CABIN JOHN PARK, PRELIMINARY PLAN 120250080 & FOREST CONSERVATION PLAN F20250330

Preliminary Plan and Forest Conservation Plan Applications to subdivide the property into three lots, for a new single-family dwelling on each lot.

COMPLETED: 12/8/2025

PLANNING BOARD HEARING DATE: 12/18/2025

Figure 4 – Proposed Preliminary Plan

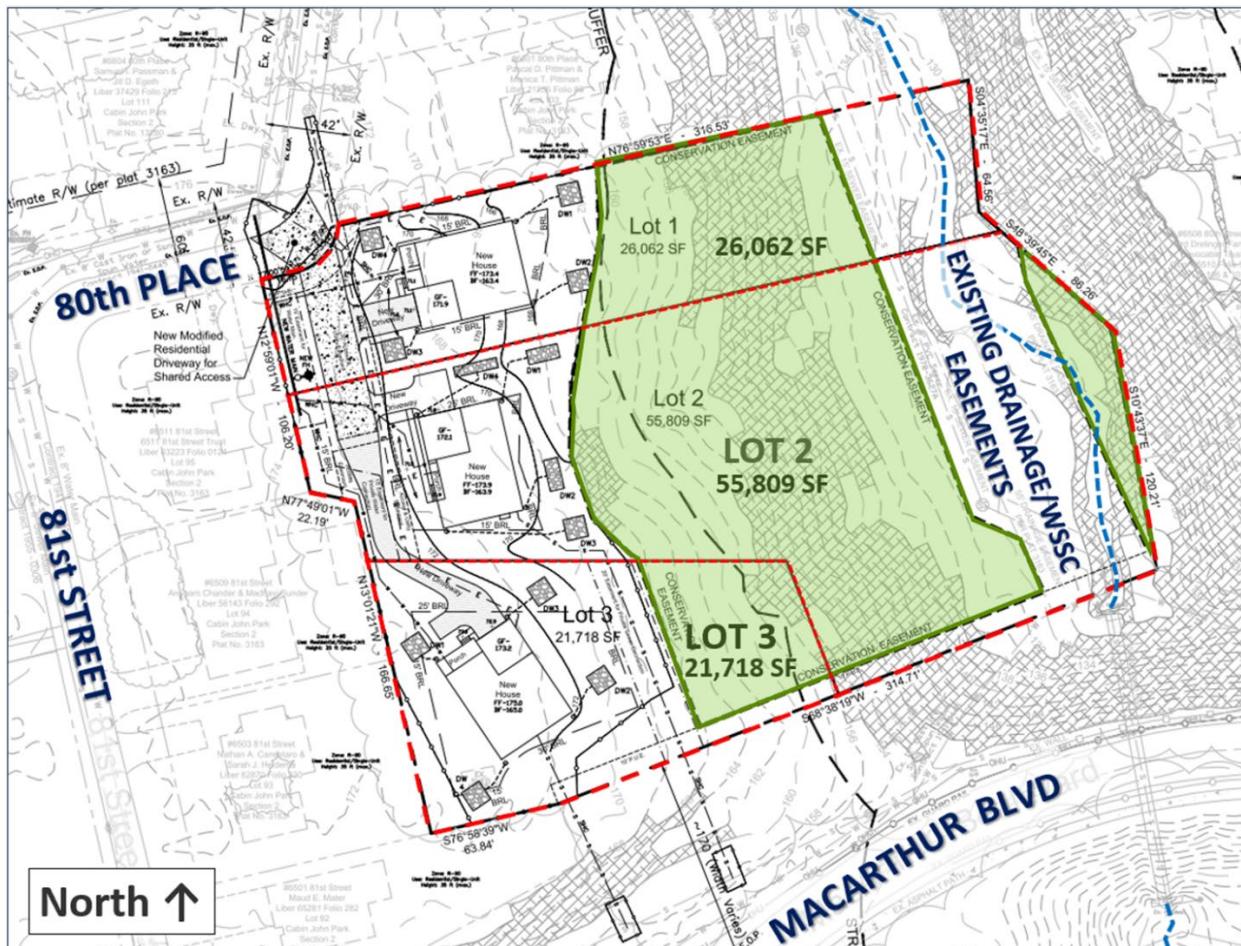
Most of the existing forest, specimen trees and environmentally sensitive areas will be protected onsite by a Category 1 Conservation easement, permanent fencing /signage and modified building restriction lines (BRLs), which are more stringent than the standards required by the zone. The lots as proposed have similar proportions of usable building area and lawn spaces as compared to the existing adjacent lots to the west which are also in the R-90 zone.

1. The layout of the subdivision, including size, width, shape, orientation and density of lots, and location and design of roads is appropriate for the subdivision given its location and the type of development or use contemplated and the applicable requirements of Chapter 59.

The layout of the subdivision, including its size, width, shape, orientation, and density is appropriate for the proposed single-family use located in the R-90 Zone, given its location and the type of development or use contemplated and the applicable requirements of Chapter 59. The proposed lots will meet or exceed the area and dimensional requirements of the R-90 zone. Minimum lot size, width, setbacks, and lot coverage are all adhered to with this application and no waivers are requested, as shown in Table 1 below.

13. The record plat must reflect the building restriction lines (BRLs) as shown on the Certified Preliminary Plan including the following:
 - a) A variable width BRL for the eastern setback for Lot 1 (located at least 25 feet from the conservation easement).

- b) A variable width BRL for the eastern and western setbacks for Lot 2 (the eastern setback must at least 25 feet from the conservation easement).
 - c) A variable width BRL for the eastern side setback for Lot 3 (located at least 25 feet from the conservation easement).

16. Before submittal of the Certified Preliminary Plan, the Applicant must make the following changes:

- a) Show resolutions and approval letters on the certified set.
- a) Include the approved Fire Department Access Plan.
- b) Add notes to each sheet indicating that coordination with the National Park Service and/or the Army Corp of Engineers is necessary for any activities within the MacArthur Boulevard ROW such as but not limited to utility connections and construction traffic.
- c) The Applicant shall add a notation under the 80th Place Notes that the “Future sidewalks to be built by others.”
